Upper Trishuli-1
10238768
Design Advice on Fish Passages for the Upper Trisuli-1 Hydropower Project test

Client:
DOOSAN ENERBILITY Co., Ltd.

Design Advice on Fish passages for the

Upper Trisuli-1 Hydropower Project

Figure 1 The weir with guiding measures.

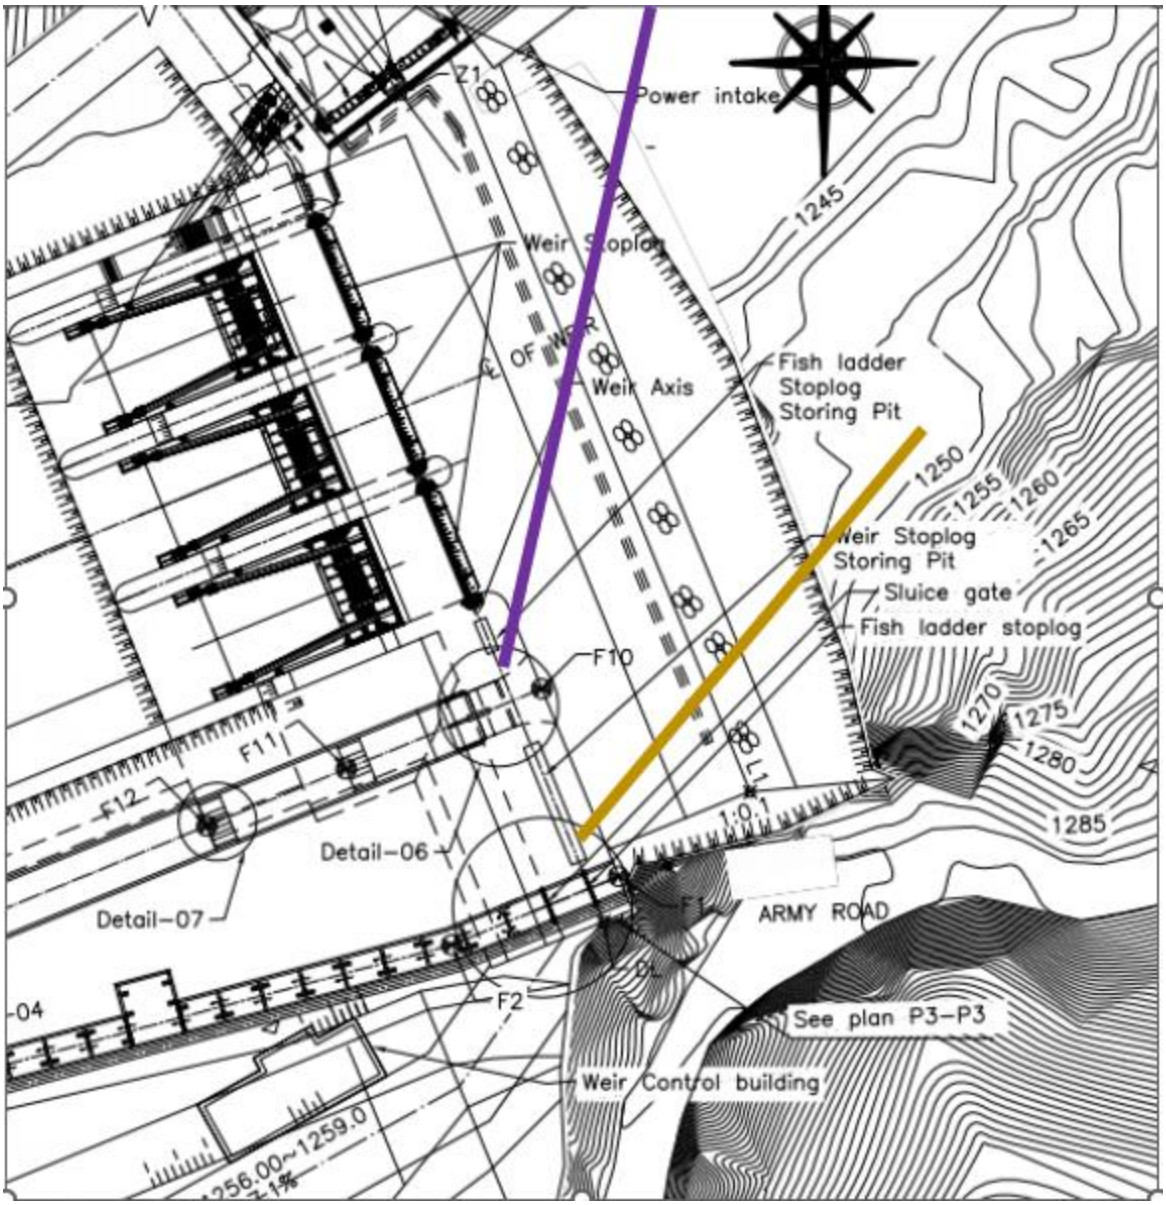
Ref. attached drawing – 13, 14, 15, 16 and Figure 1 in this report.

A new flapped gate with capacity 15m3/s and a fish friendly spillway for downstream fish passage is provided..
For the effectivity of the fish passage, a gate with higher flow capacity would be preferable. See Figure 3. See also the enclosed Drawings of flapped gate and spillway.

Yellow line: An impermeable curtain to secure calm water for fish entering the reservoir from the fish ladder. The curtain cover the distance from the weir to the shore at the other side of the reservoir. The first 5 to 10 m of the curtain cover the water column from surface to bottom, the rest of the curtain is 2m deep and anchored to the bottom.

Purple line: floating curtain for guidance of fish to the spillway. The curtain is 2 m deep and the lower 1m can be made by a net with mesh size 10mm. The curtain must be made by a strong fabric so as it is possible to also guide debris to the spillway. The enclosed drawings show mor in detail the Flapped gate and the spillway.

LONGITUDINAL PROFILE OF FISH LADDER

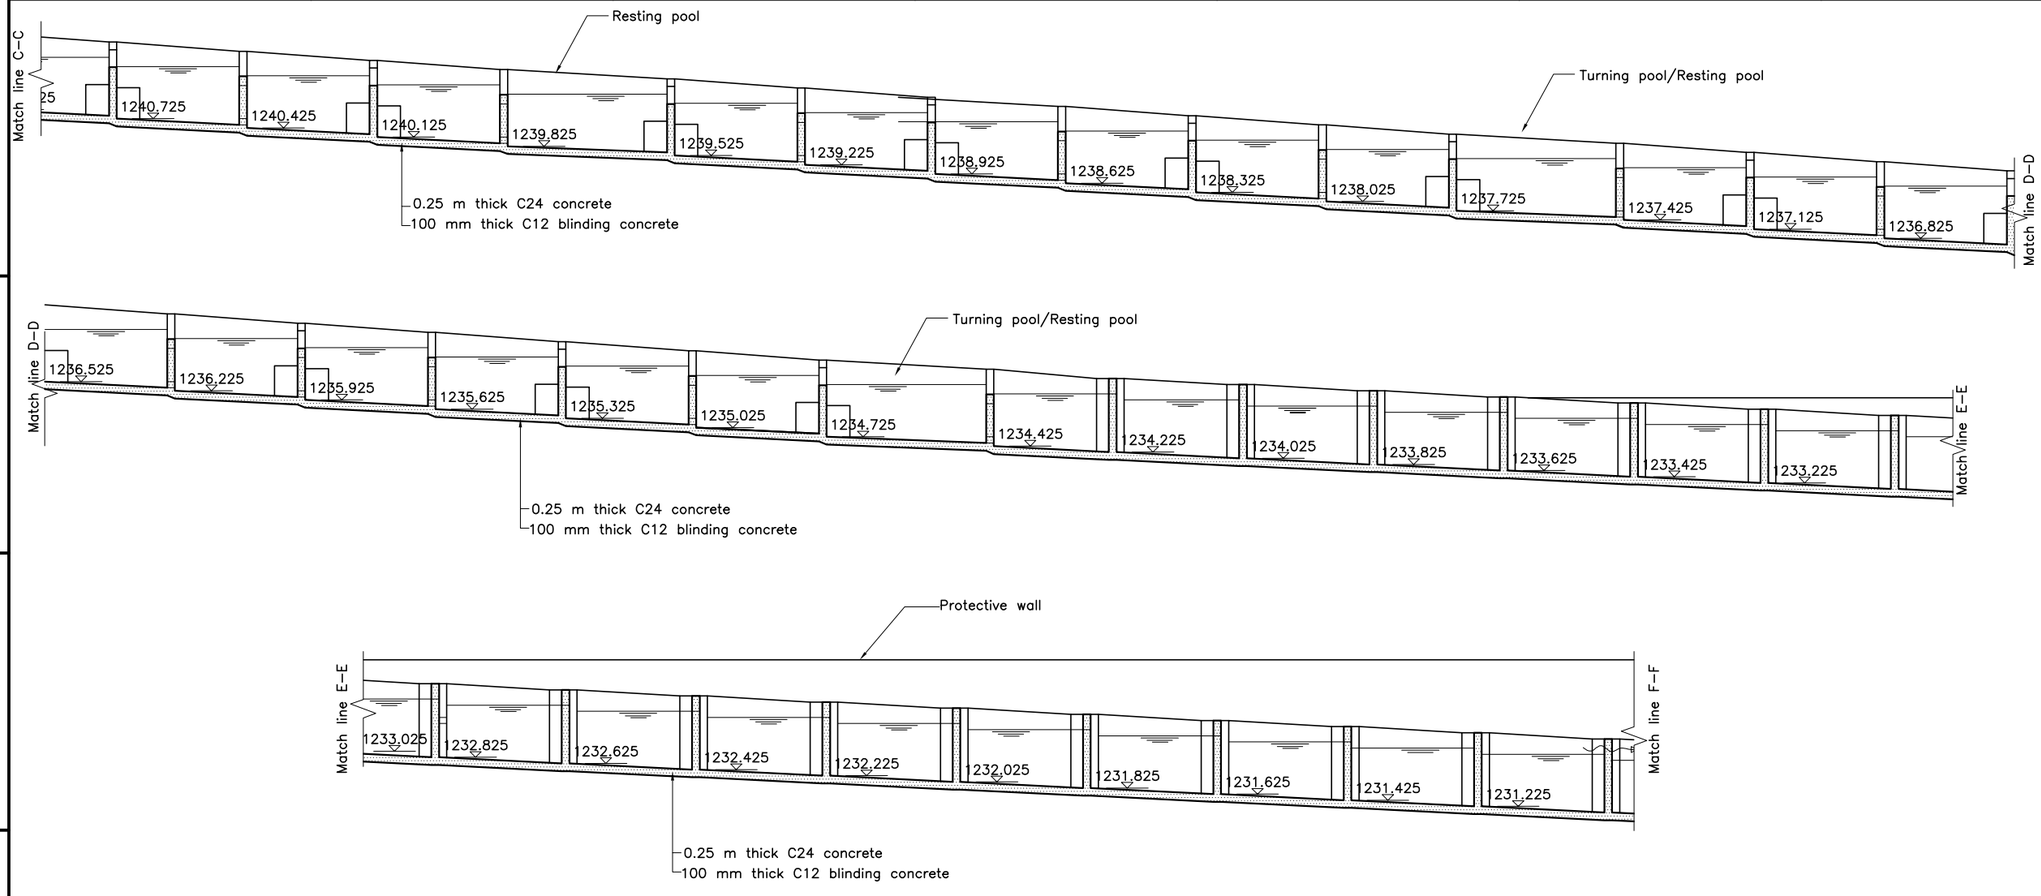
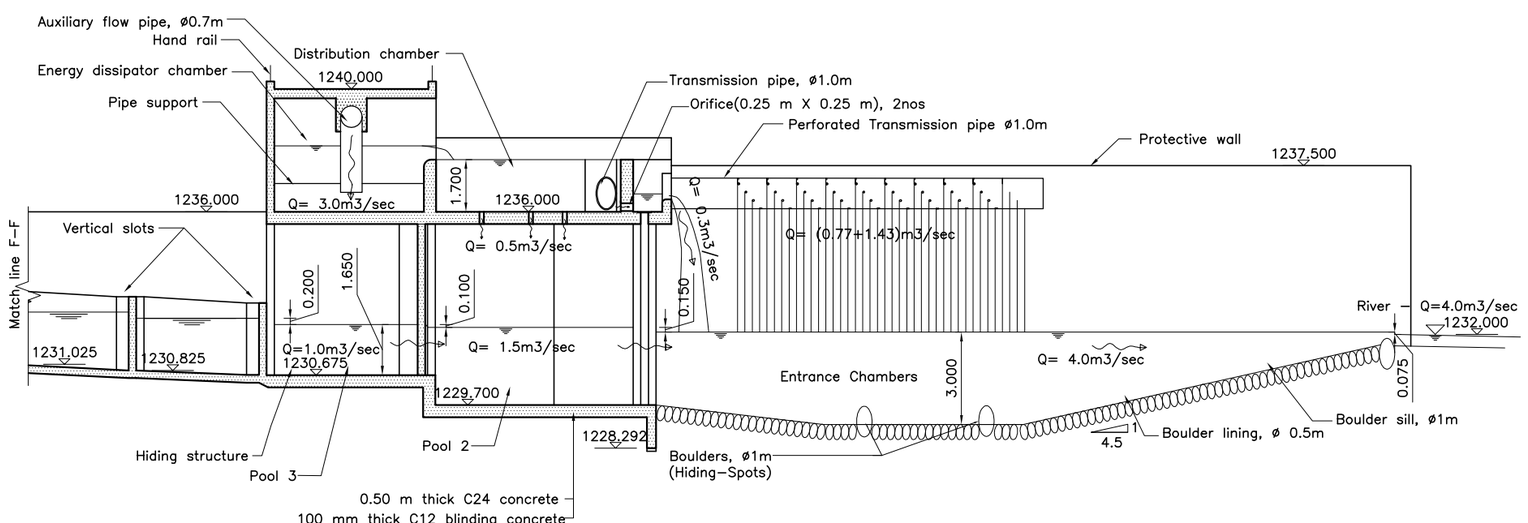
Ref. attached drawing -03, -06, -07

Ref. attached drawing -03, -06, -07

PLAN AT J–J
TYPICAL PLAN OF NORMAL AND RESTING POOL
Scale 1:100

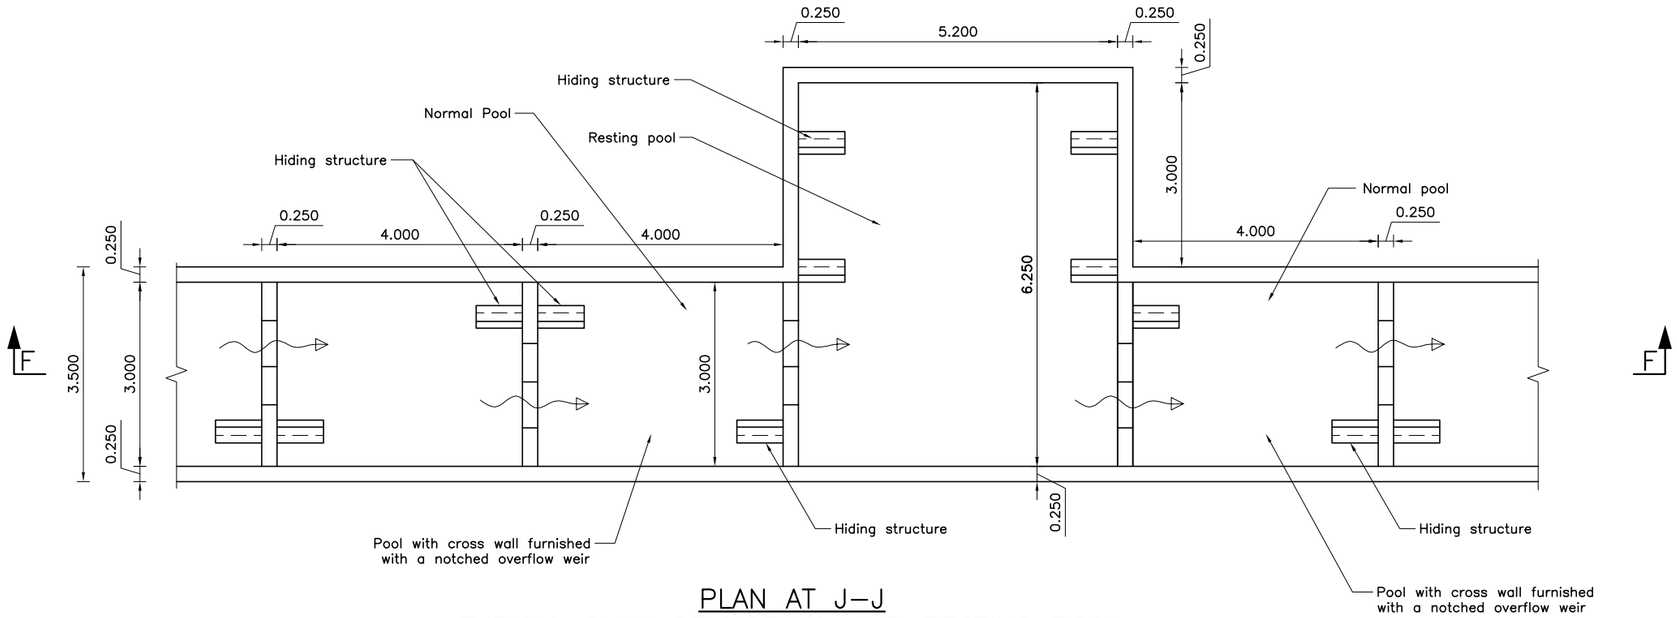
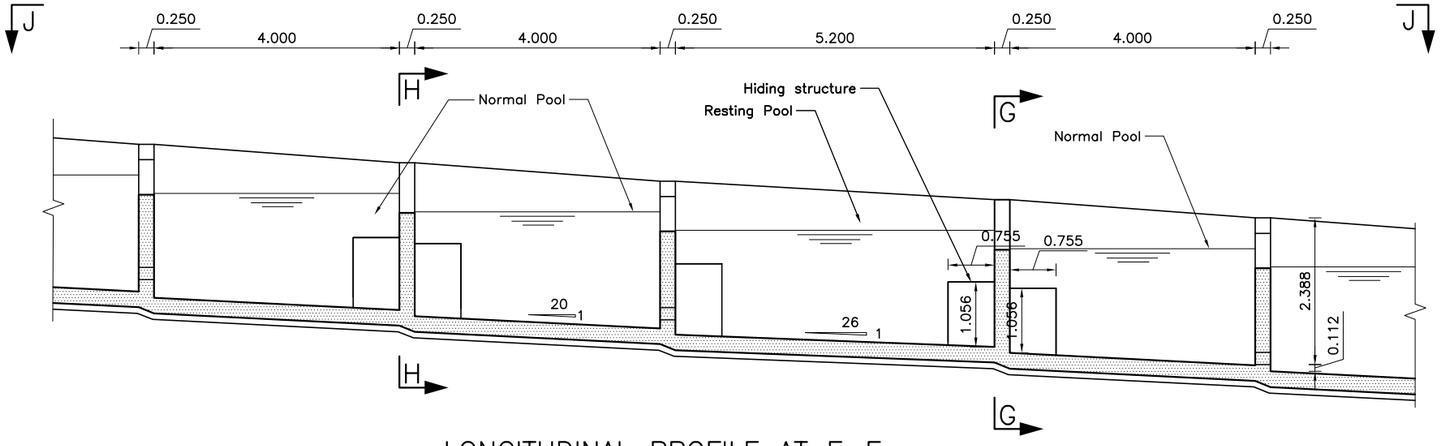
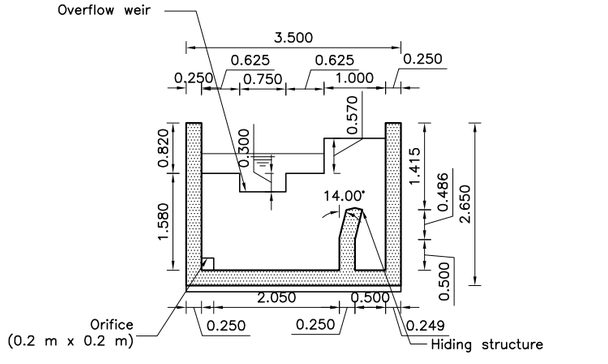
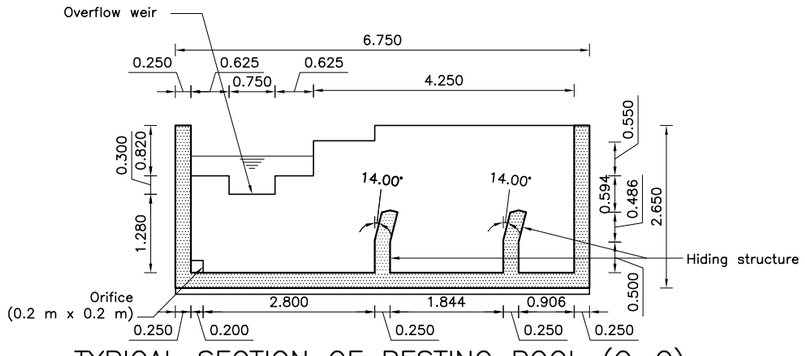
Ref. attached drawing, -05, -09, -10, -11, -12, -17, -18, -19

Ref. attached drawing -05, -12,.

The fish-way is provided with resting pools. On the downstream section, every 10’th pool is planned to be of this type. In the upstream section from pool no 30, the distance between each resting pool is reduced. The upstream section of the fish ladder is planned with this pool type for every 7’th pool.

PLAN P1–P1
ENTRANCE OF FISH LADDER
DOWNSTREAM

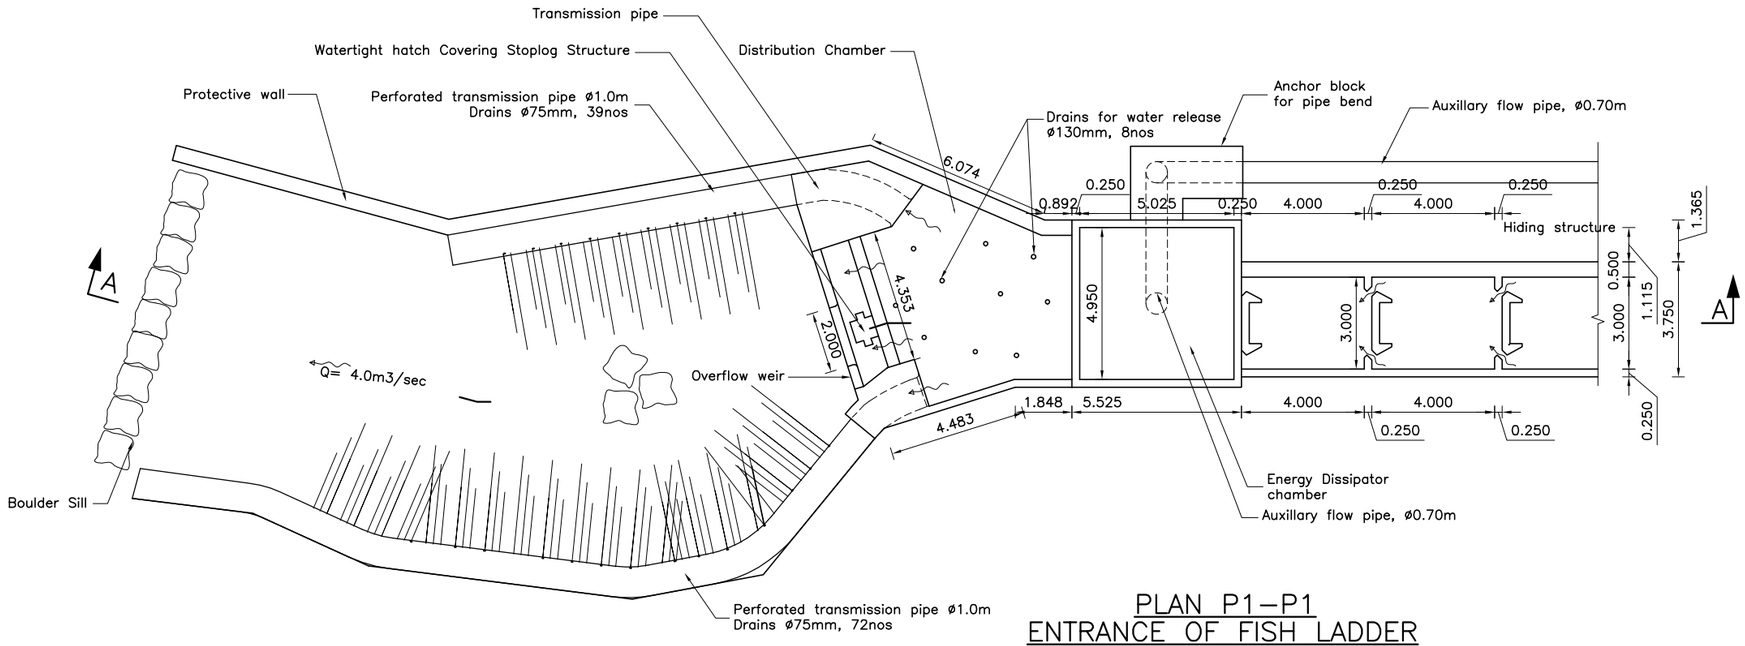
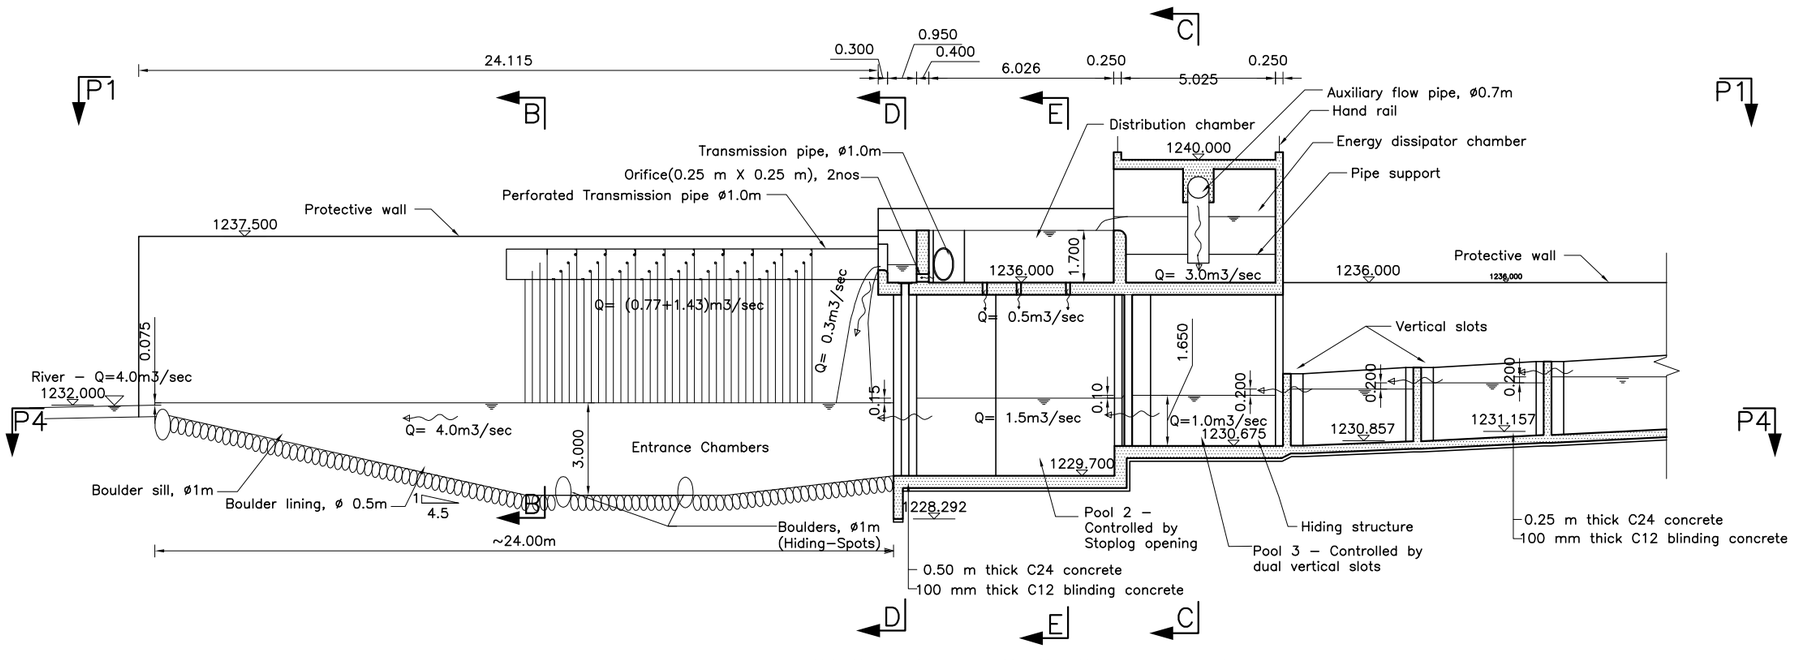
Ref. attached drawing -01, -03, -06, -07

The entrance pool is an excavated basin located adjacent the river course. It is approximately 24 m long measured along the centreline. Width varies between 9 m and 13 m. Floor is sloped and resulting max water depth is approximately 3.0 m. Some boulders are situated in deepest section of the chamber facilitating hiding spots for the migrating fish. The pool is framed by the excavated rock slope on one side and a protective wall on the river side. A boulder sill serve as the control unit.

The boulder sill in the outlet of the entrance pool (pool no 1) is approximately 10 m wide. It is assumed buried into the river ground and as a type where the gaps between the large boulders are closed. The boulders is assumed to consist of fieldstones. The sill is drowned by the river flow. Assuming Q = 4.0 m3/sec and ditto in the river, the sill is estimated to raise the water level by 0.075 m in the entrance pool.

If the entrance pool localisation as shall be decided by Doosan Enerbility is close to 1232 masl the protective wall must reach up to at least average monsoon flow level which might be close to 1235,5 masl. (HEC-Ras run with Q = 411.0 m3/sec)

Total water flow entering the entrance pool is planned as Q = 4.0 m3/sec of which Q = 1.5 m3/sec is fed from the upstream pool 2 via a stoplog-opening (Δh = 0.15 m), and Q = 0.3 m3/sec from pool 2 roof via an overflow weir. This flow is a free falling jet entering the water surface in front of the pool 2 stoplog-opening.
